**Date:** November 26, 1996

**From:** Frank Gasparik

**Subject:** SPI-2 Rev. 11  
Timing Specifications

Figure 20A - LVD Receiver Example

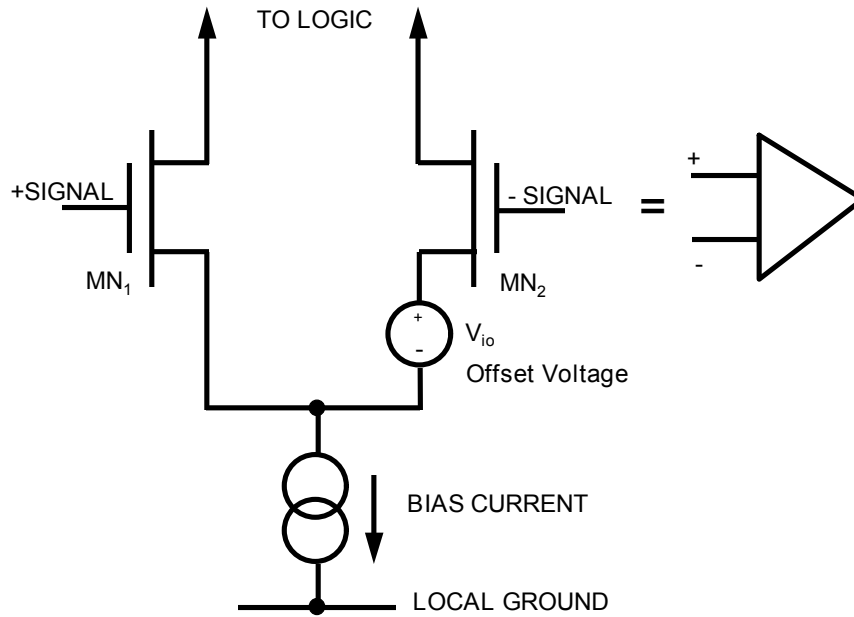
Please refer to Figure 20A below. This is a modified Figure 20 from the SPI-2 document. If the receiver is implemented with either N or P-channel differential pair, there is an inherent input offset voltage,  $V_{io}$ . This input offset voltage is caused by a number of physical factors such as threshold mismatch and thermal gradient between the  $MN_1$  and  $MN_2$  devices, layout symmetry, masking photo-lithographic process variations, load mismatch, etc. Under ideal layout conditions, the input offset voltage has the Gaussian distribution, i.e. it has both +/- polarities. Depending upon the process control the three sigma  $V_{io}$  can be of the order of a few 10's of mV.

The receiver's minimum differential input signal has to overcome this input offset voltage and also to provide some overdrive, depending upon the gain of the receiver. As a reference point let's use for the  $V_{io}$  effect +/- 20mV. The overdrive depends upon the design implementation and the desired speed of the receiver. We can use any number from say 10 to 20mV. This will give us a minimum differential input signal of approximately 40mV.

Figure 24 - Definition of timing measurement points

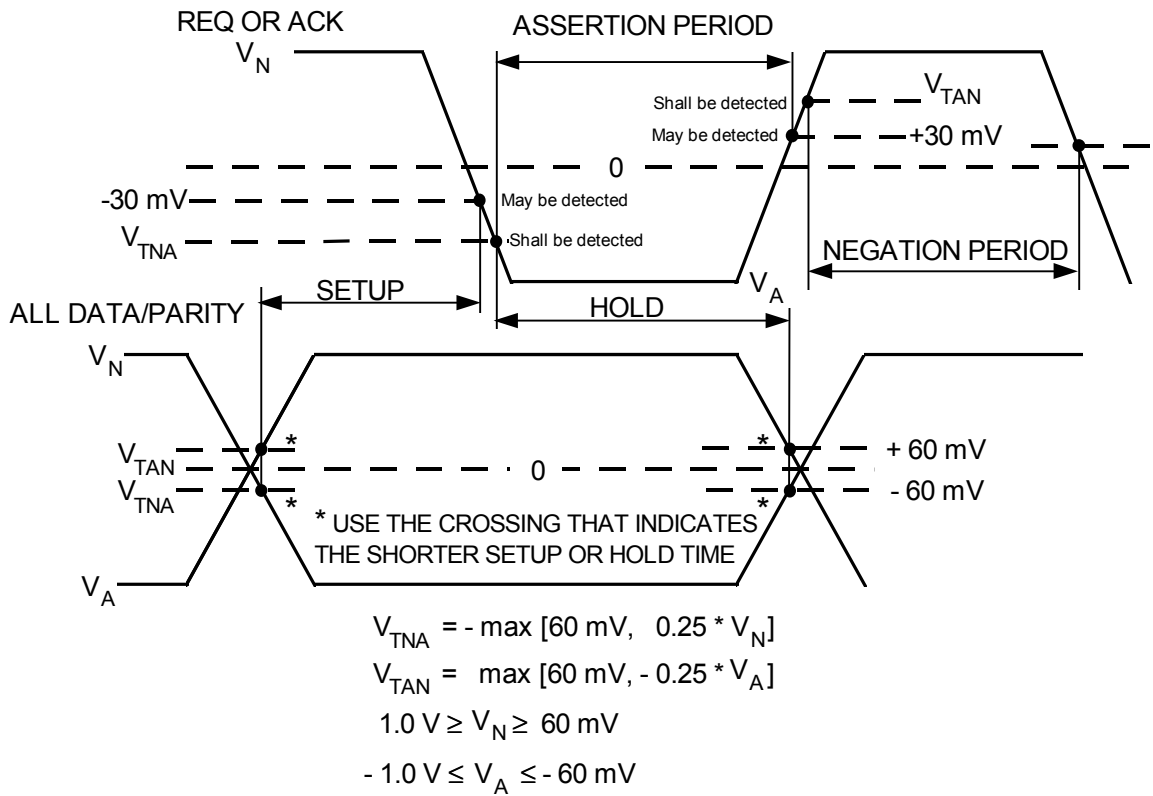
Figure 24 need slight modification as indicated below. Then it will agree with the definitions of the Fast-20 document Figure 1B which is also included below.
